ONSITE SEWAGE DISPOSAL SYSTEM DESIGN PLAN

FULTON MANOR VALLEY - LOT 9
 12159 FULTON ESTATES COURT
 FULTON, MD 20759

MEMORANDUM

RE: 12159 Fulton Estates Court
Fulton, MD 20759
"OSDS Plan"

WALL CHECK DRAWING
12159 FULTON ESTATES COURT
LOT 9
FULTON MANOR VALLEY
PLAT NO. 23141
FIFTH ELECTION DISTRICT
HOWARD COUNTY, MARYLAND

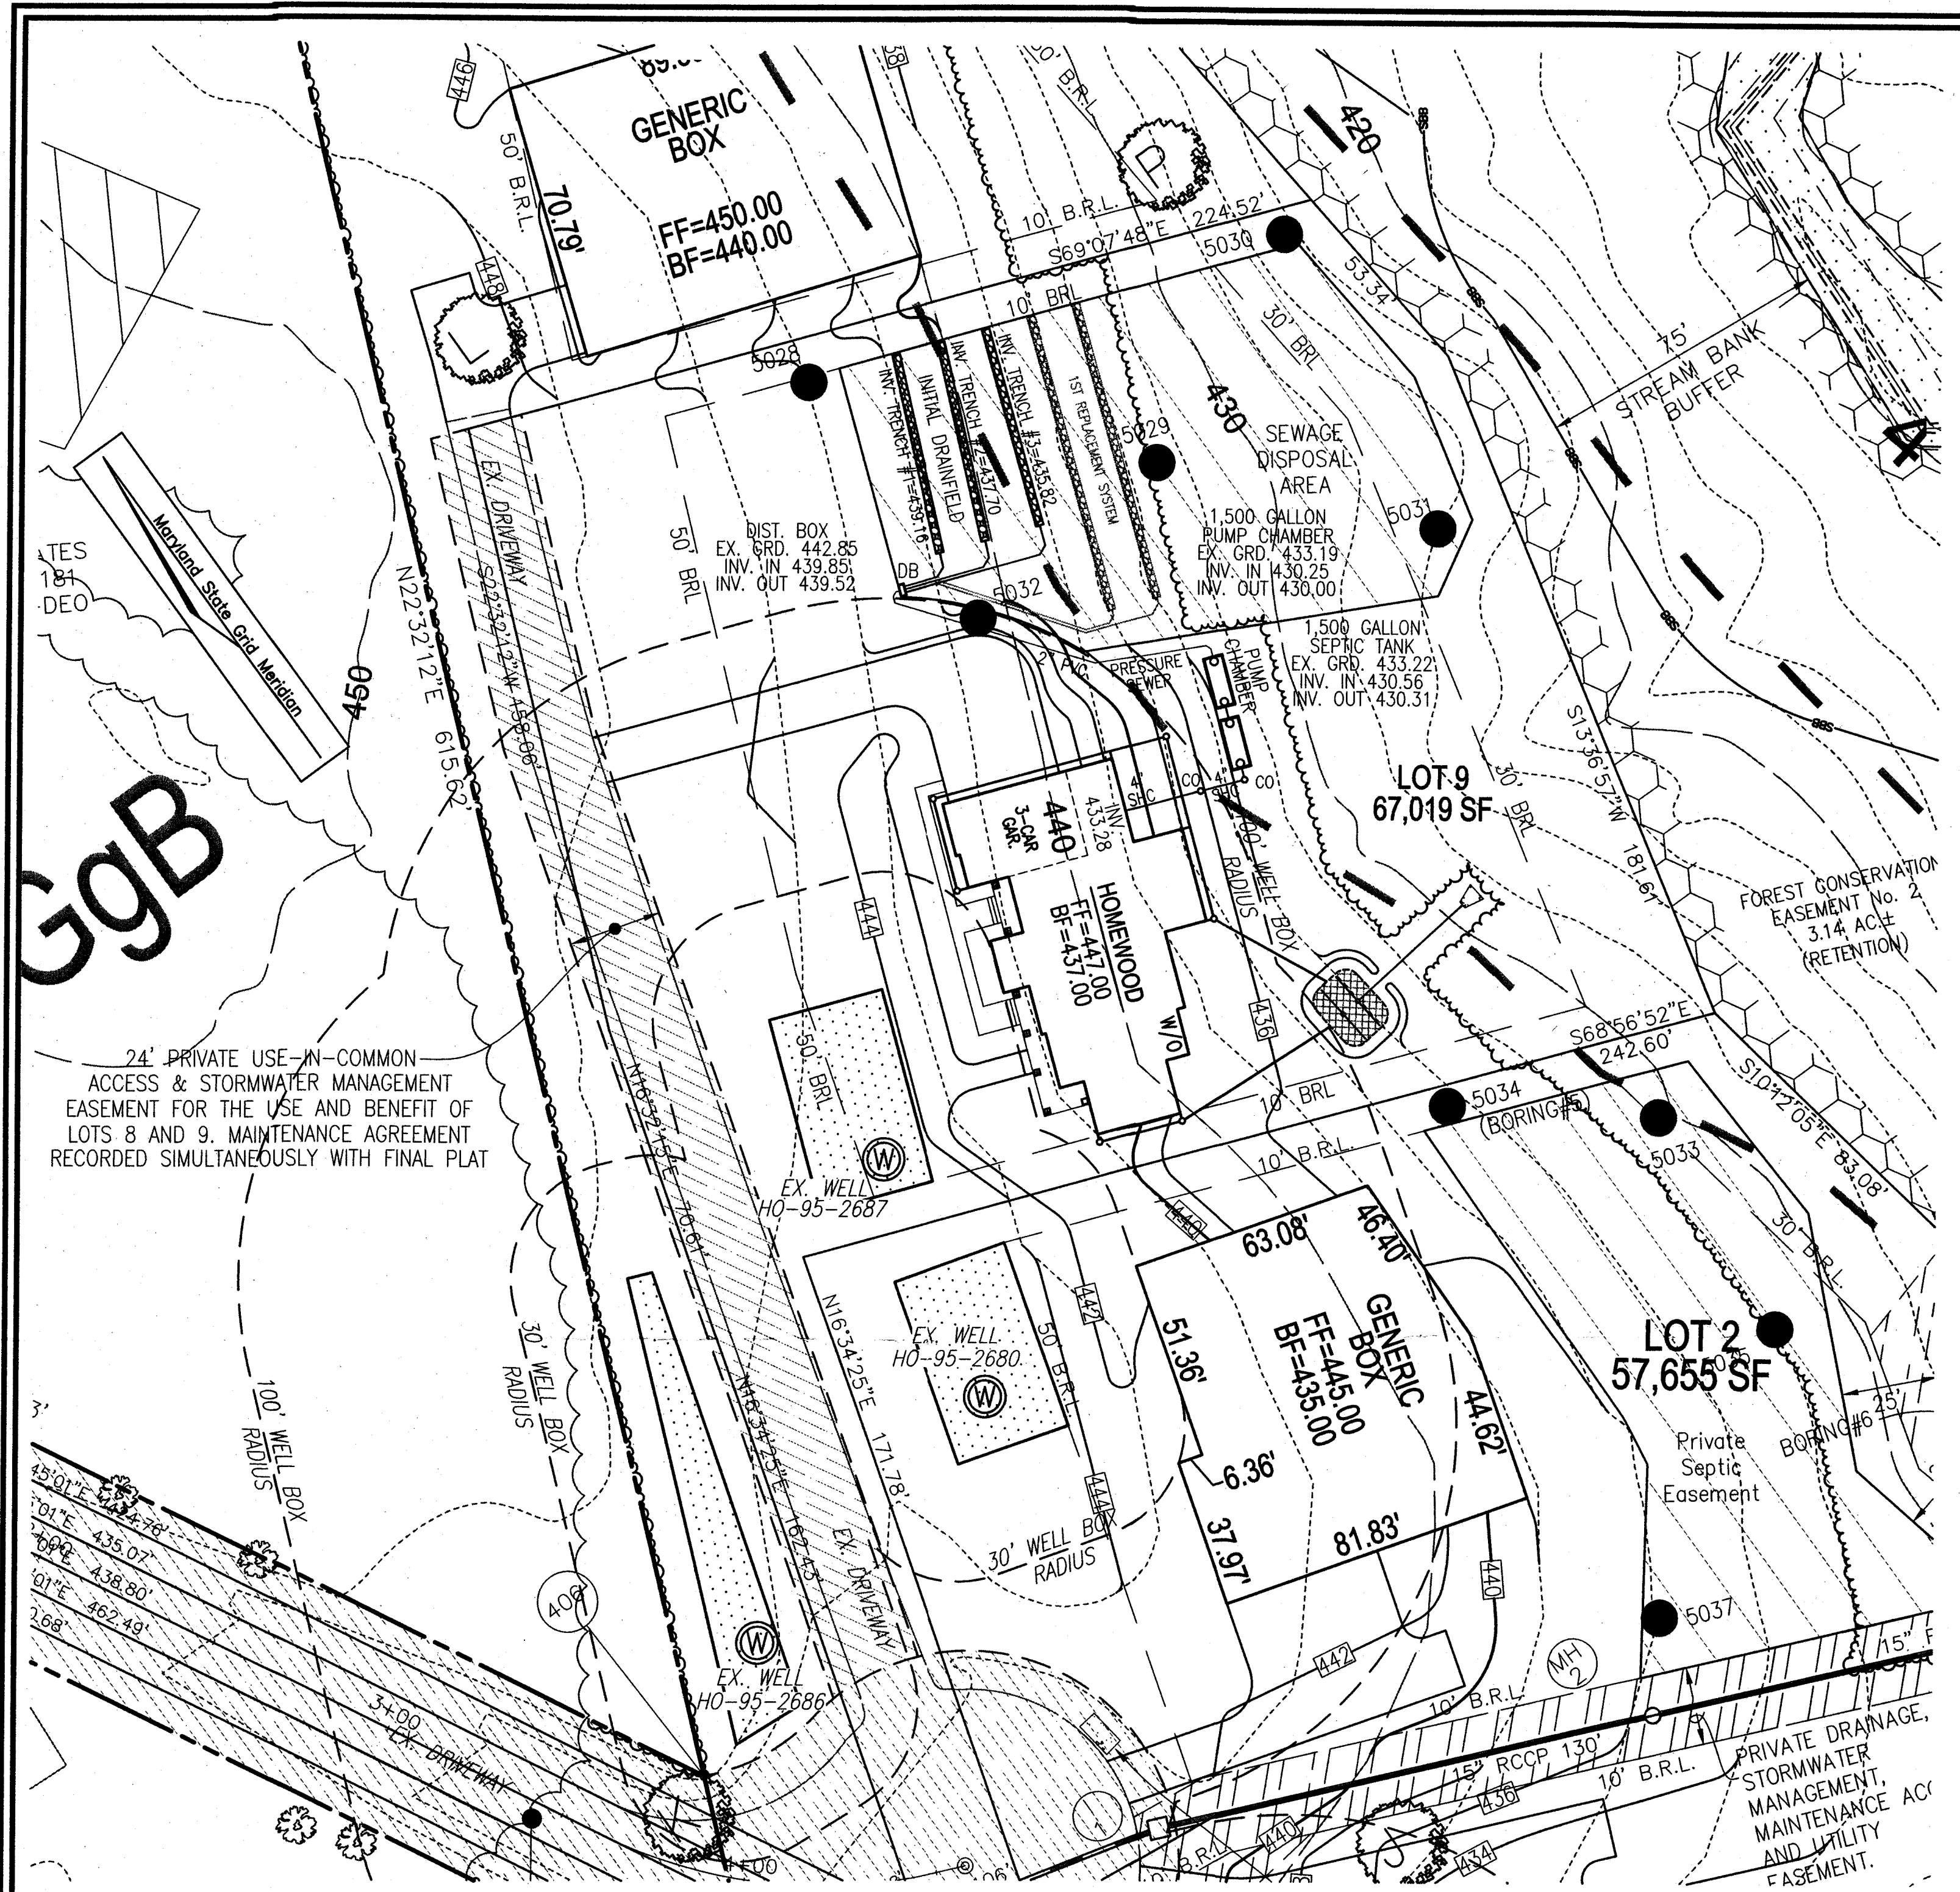
Wall Check
OK
RAE 4/10/17

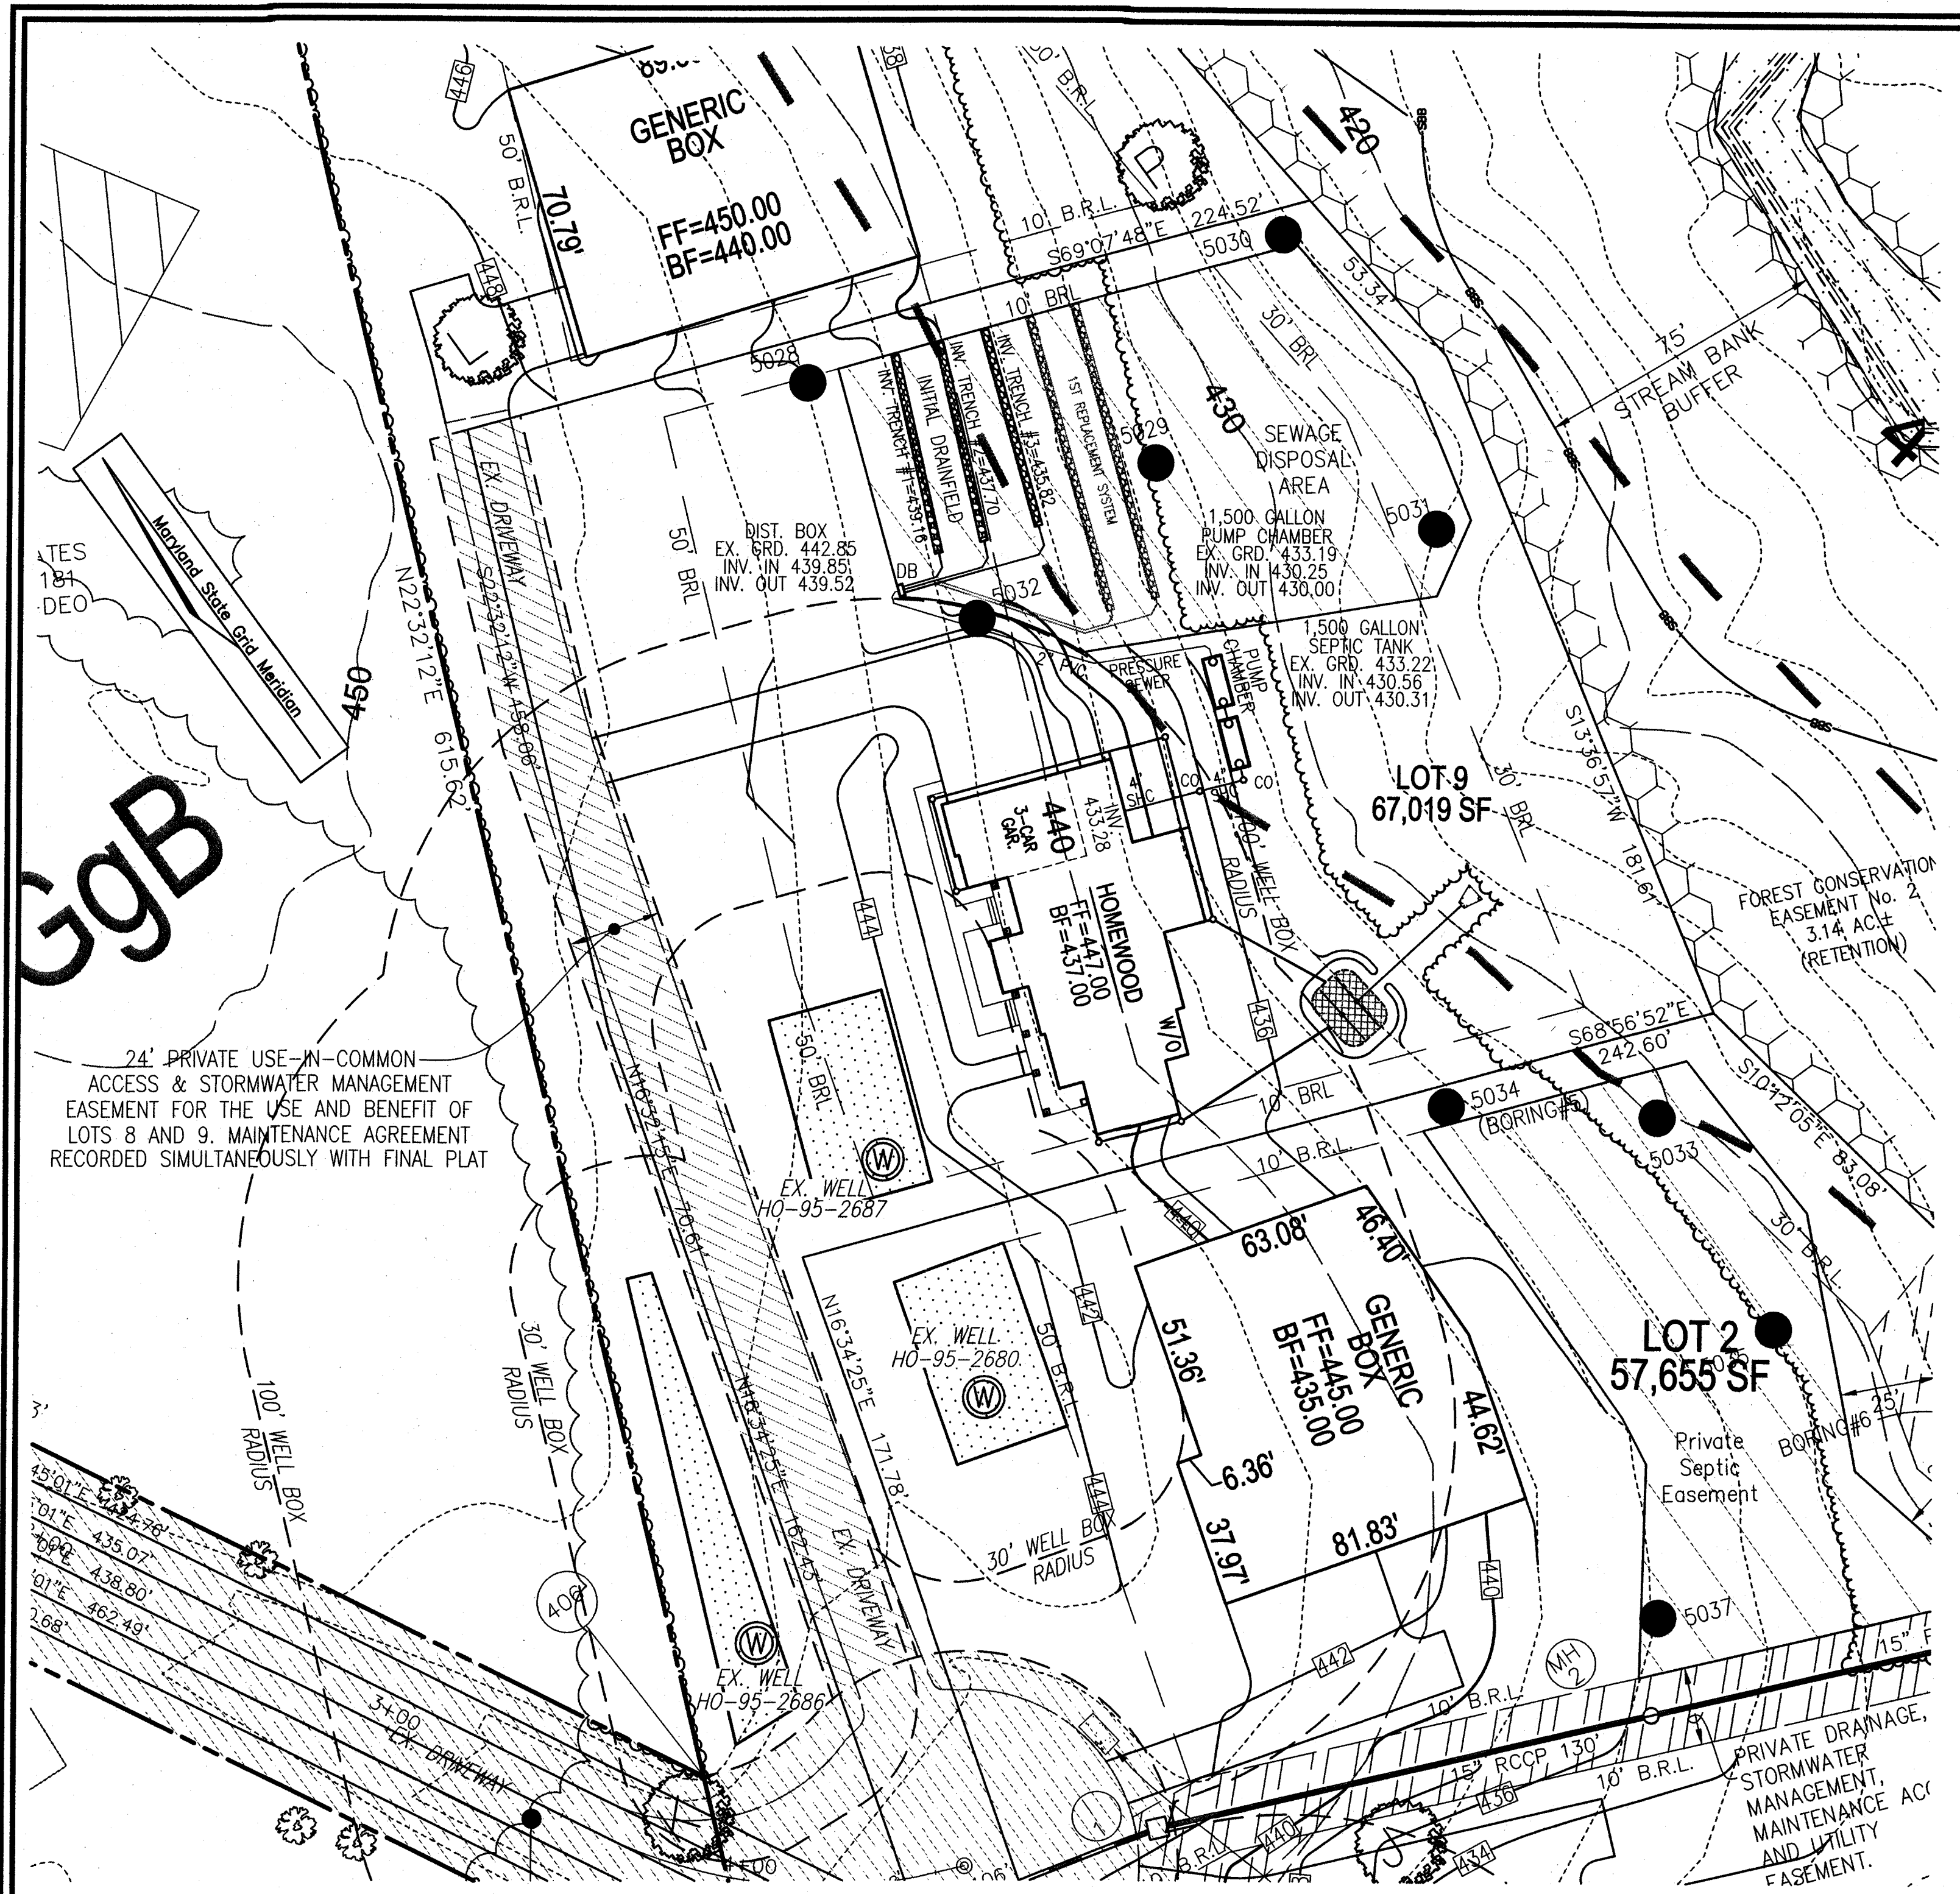
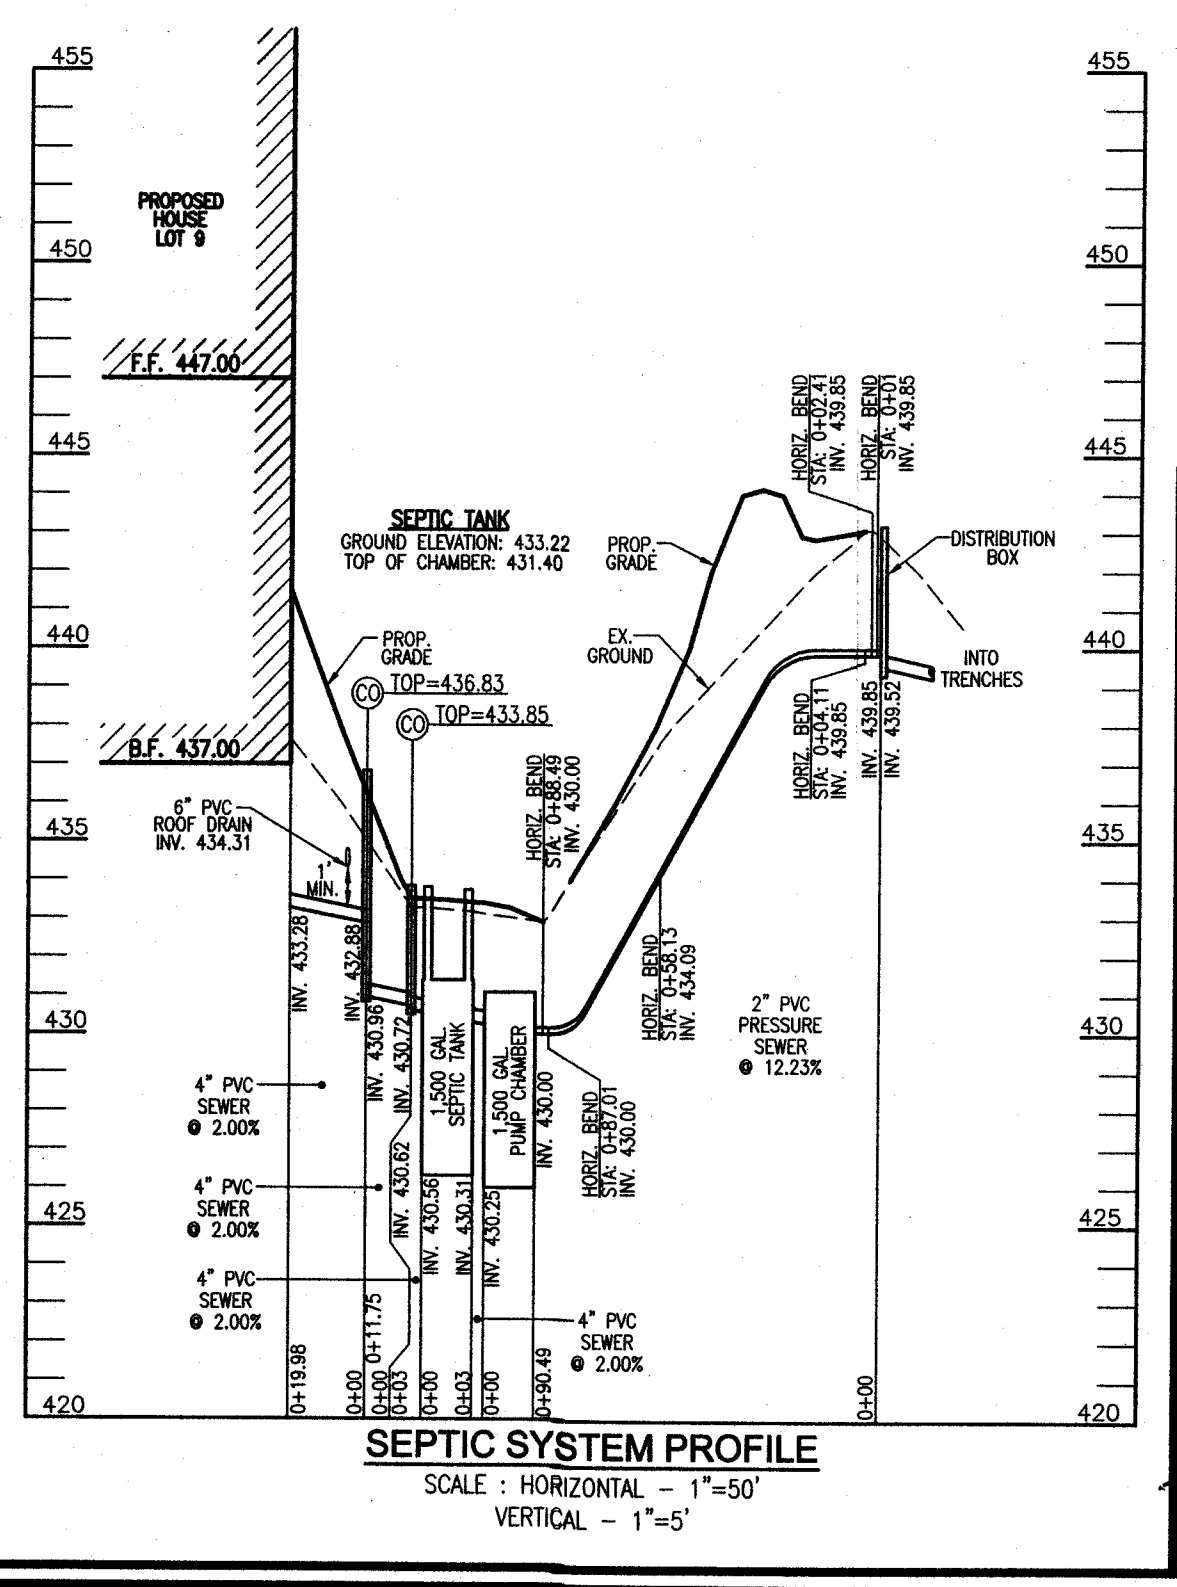
I received the new plan with the revised pump chart however the pump chosen (WEO5H) was not corrected. Pump WEO3L or WE03M would be more appropriate. You can either send new revised copies, redline line it yourself at the Health Dept. or I can redline it for you to the pump of your choosing. Let me know what you want to do.

I received the OSDS plan for 12159 Fulton Estates and noticed an error that needs to be corrected. On the pump curve 15 meters of total head is selected instead of the 15 feet as calculated which is making the pump stronger than it needs to be. You can either send me revised plans or if you wish to come to our office and redline the plan that would be fine as well. Let me know if you have any questions and what you decide. Thanks.

Could you revise the plan to specify the WE03M please? Let us know if that will be a problem.
